AC BLOWER INOPERATIVE DTC 912F87 IN ACC "THE FRONT BLOWER REGULATOR HAS A MALFUNCTION. THE MESSAGE IS MISSING"

DEALER TECH TOPICS; OCTOBER 2014

Reference Number(s): TT 10/14,Â Date of Issue:Â October 2014

MERCEDES-BENZ: Model 166

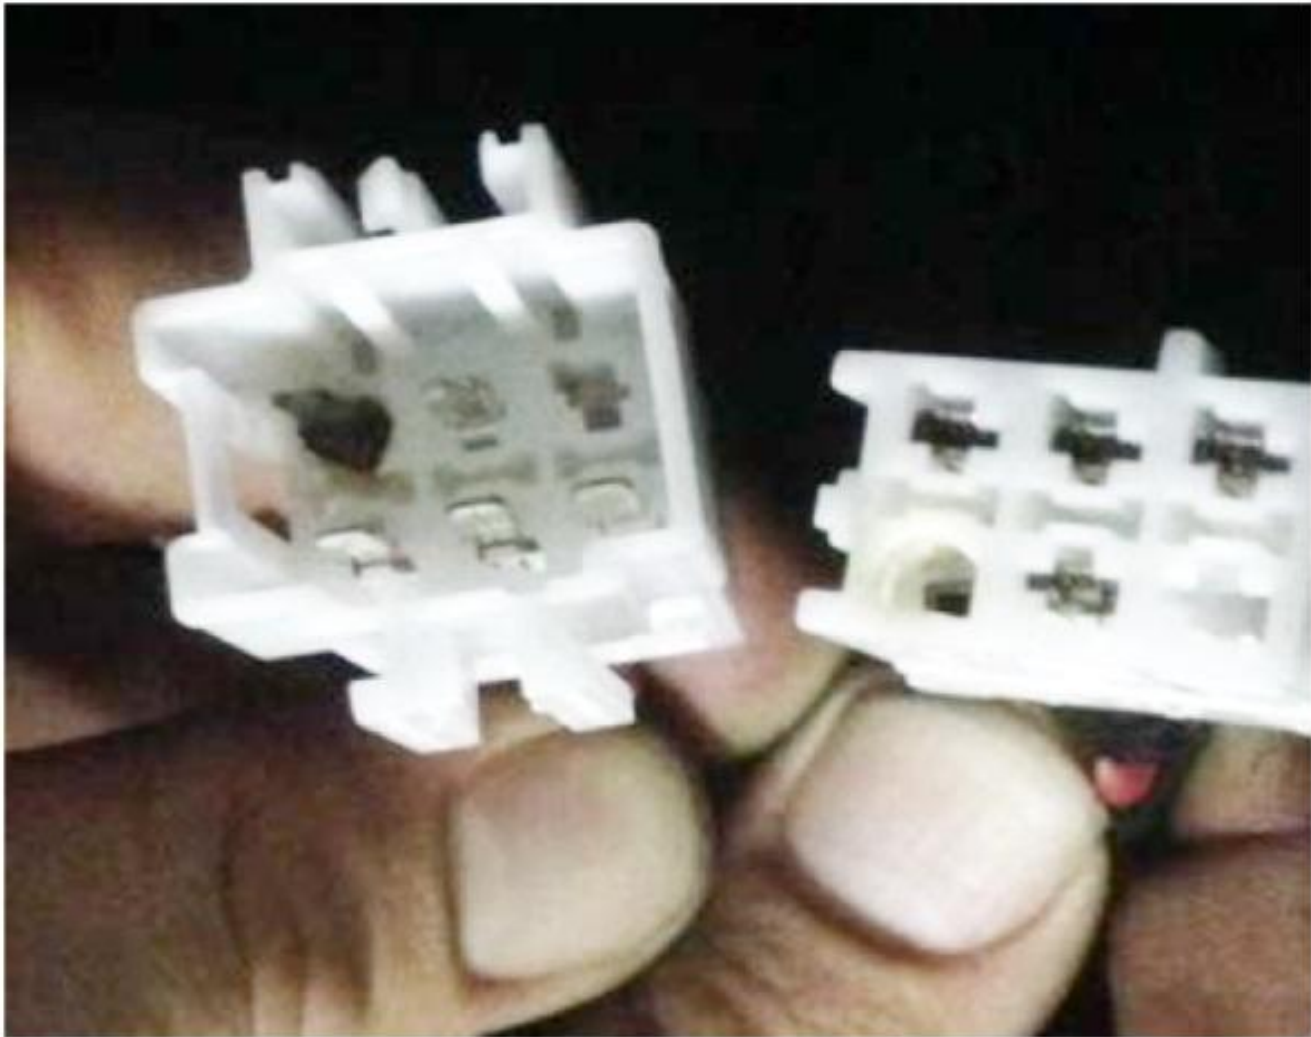
Possible connection failure at connector X18(2) pin 2.

A0375459428: 6 Pin Housing

A2205456928: 6 Pin Bushing Housing

A0115450726: Female SLK2.8 4.0mm² Pin

A0355457628: Male SLK2.8 4.0mm² Pin

NOTE: If other pins are damaged, refer to wiring diagram for wire size and laminated sheet in Wiring Harness Repair Kit for correct SLK2.8 pins.
